UNITED STATES
DEPARTMENT OF THE INTERIOR
BUREAU OF LAND MANAGEMENT

SUNDRY NOTICES AND REPORTS ON WELLS
Do not use this form for proposals to drill or to re-enter an abandoned well. Use form 3160-3 (APD) for such proposals.

PROCEDURE TO RECOMPLETE IN SEVEN RIVERS
Pearsall Queen Sand Unit #18 (name will change to Legacy #1)
Pearsall, Seven Rivers Field
Lea County, New Mexico

Legacy Reserves Operating Conditions of Approval

Proposed wellbore diagram

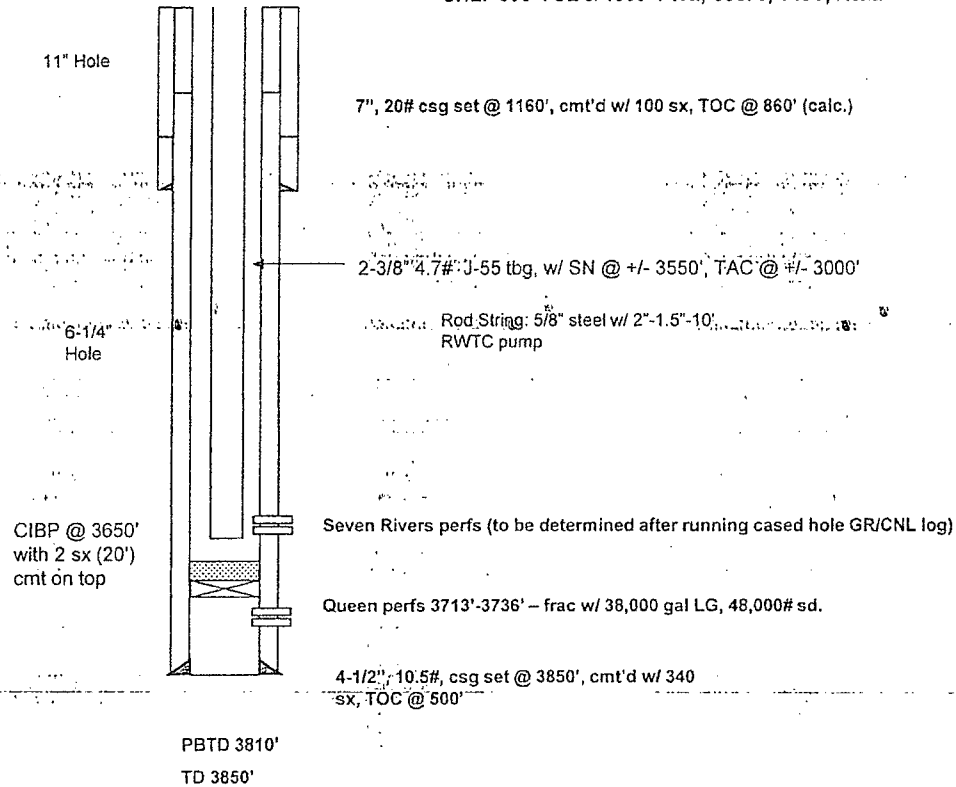
4. **Provide BLM with an electronic copy (Adobe Acrobat Document) of a cement bond log recorded from 3500' to surface. This is to confirm top of cement.**

6. **Operator shall place a CIBP at 3650' and place 35' cement on top. Tag required. Tag to be witness by BLM field inspector.**
7. **Must conduct a casing integrity test before any perforating** or fracturing can be done. Submit results to BLM. The CIT is to be performed on the production casing to 500 psig for 30 minutes and chart recorded.
